Fuel Pressure Sensor: All Technical Service Bulletins Fuel System/Engine Controls - MIL ON/DTC P0191 Set

TSB 07-4-7

MIL ON WITH DTC P0191 - FUEL RAIL PRESSURE SENSOR CIRCUIT PERFORMANCE

FORD:
2005-2006 Five Hundred, Freestyle

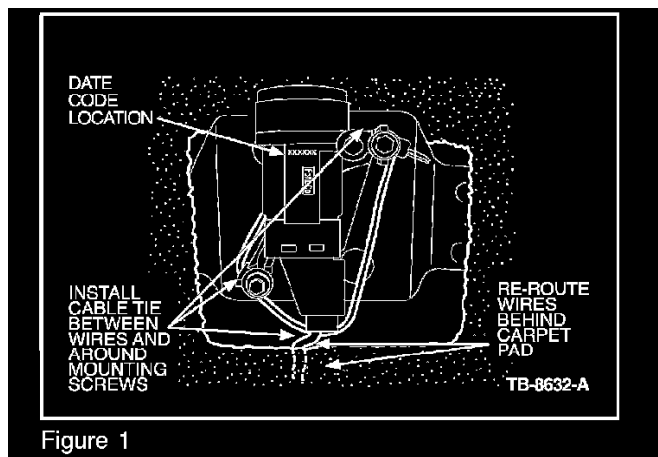
4. Inspect inertia fuel shutoff (IFS) located in front passenger foot well for loose or disconnected wiring/connector and build date code on switch. If switch was built before November 2005 (5 L XXX) replace switch. Date code is visible without removing switch and is located near top of switch. (Figure 1)
 - a. Format is Year (4=2004, 5=2005, 6=2006) Month (A=Jan, B=Feb, C=Mar "I" is not used) Day (1-31) Shift (X or Y). On all vehicles,

reroute inertia switch wiring behind/under carpet pad and install cable tie over connector. (Figure 1)
